APPENDIX J

PROCESS TEAM MEETING/CONFERENCE CALL
NOTES

Subject: Project Kick-off Meeting	
Client: South Dakota Department of Transportation	
Project: Watertown South Connector	Project No: 39319
Meeting Date: 6/8/06; 1:30 p.m.	Meeting Location: SDDOT Watertown Area Office
Notes by: ju	Notes to: attendees

Figure 2-6a

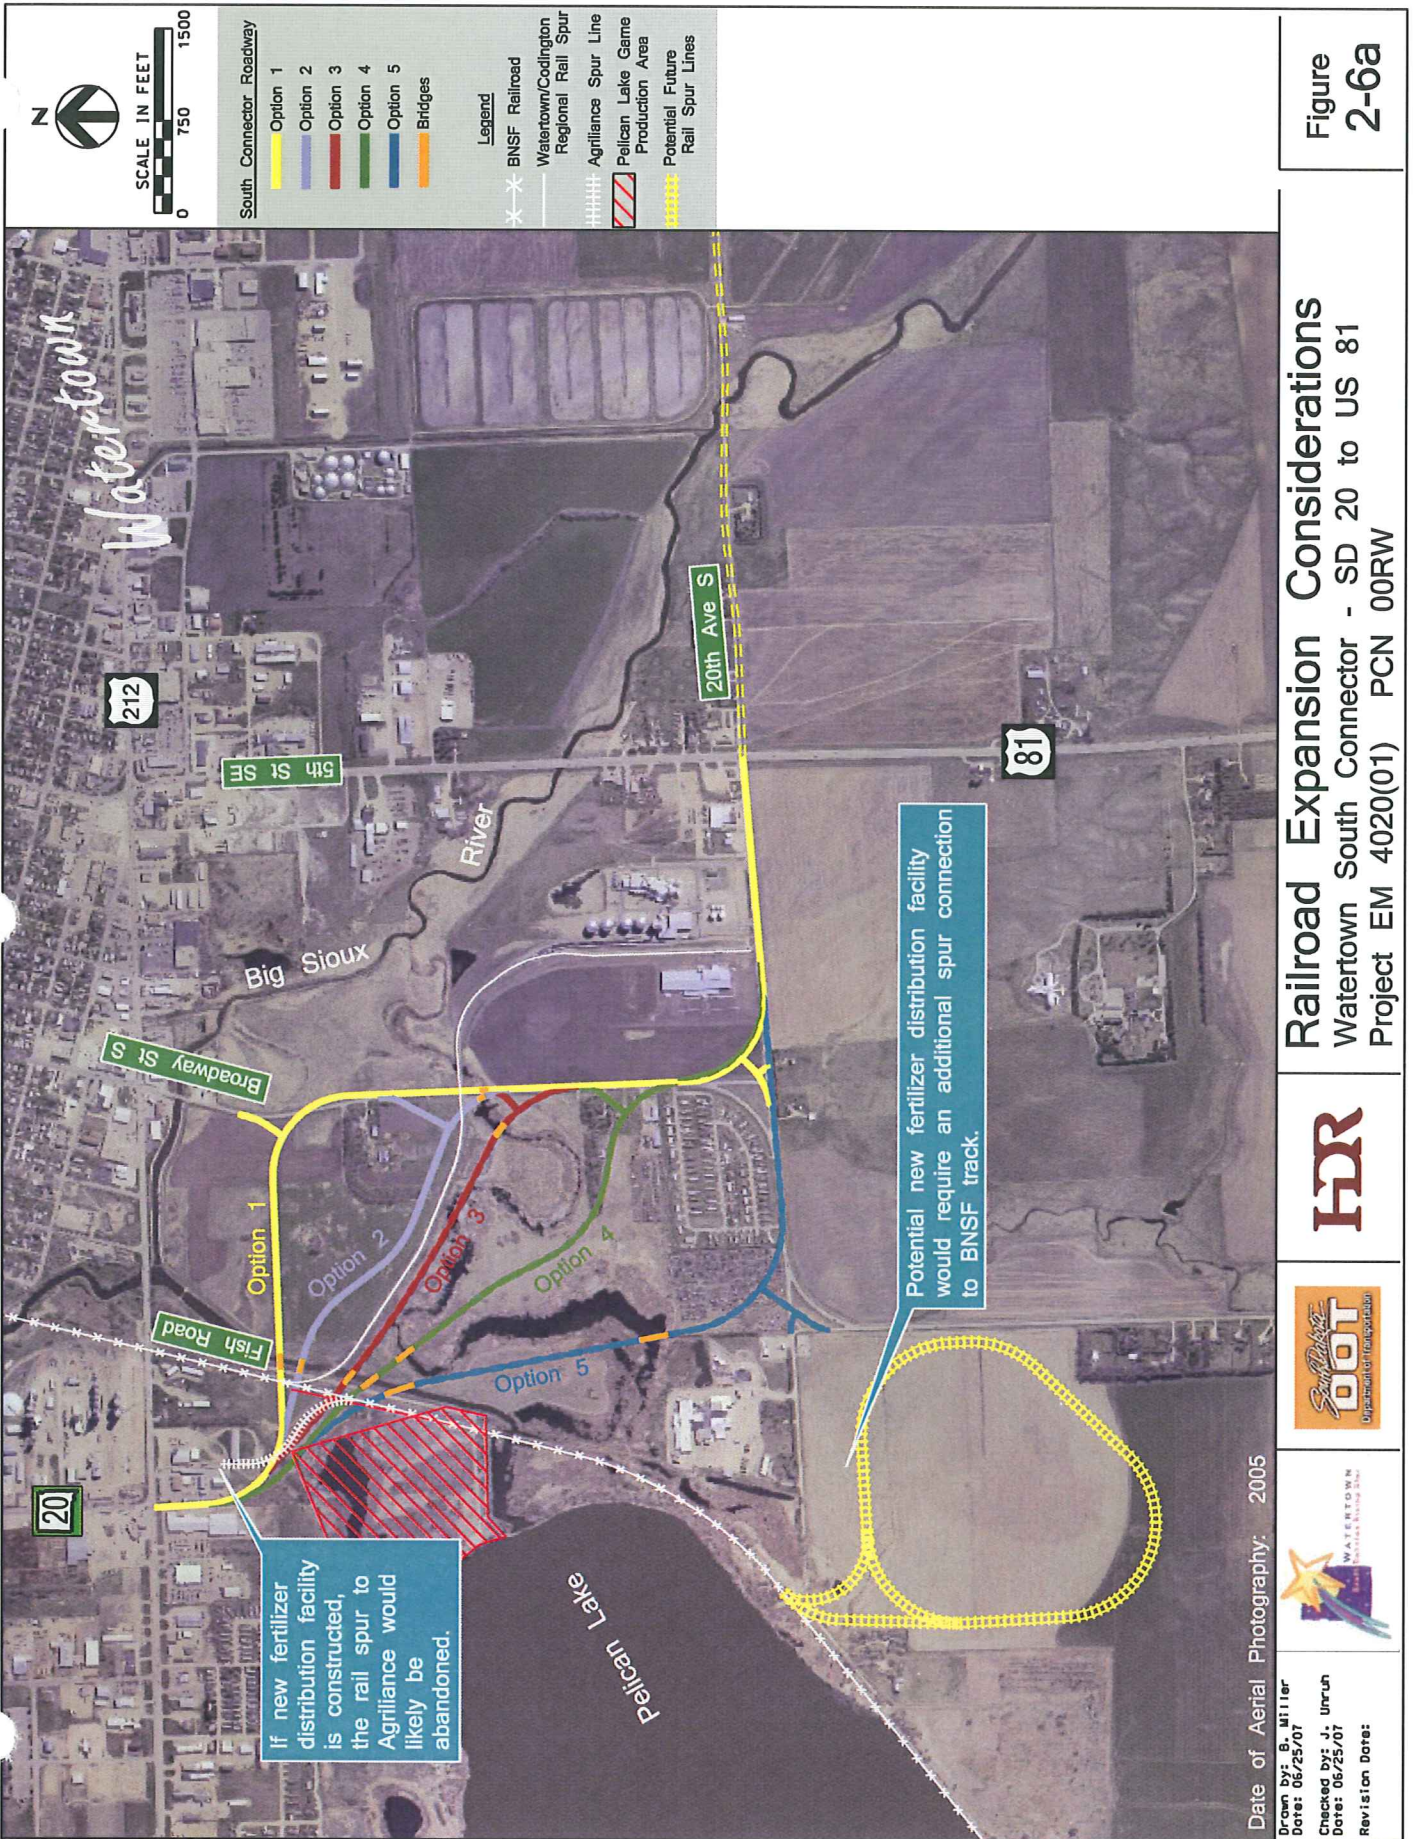
2. BNSF/South Connector at-grade rail crossing:
 - BNSF policy of no new at-grade rail/roadway crossings remains in effect.
 - There was discussion of a grade separated crossing. This has not been analyzed in detail and is likely not a cost-effective option. Environmental impacts of a grade-separated crossing would likely be significant. It was noted that if an existing 'at grade crossing' can't be identified for closure, the BNSF may require an overpass. The feasibility of an overpass is undetermined but would have significant financial impact to the project.
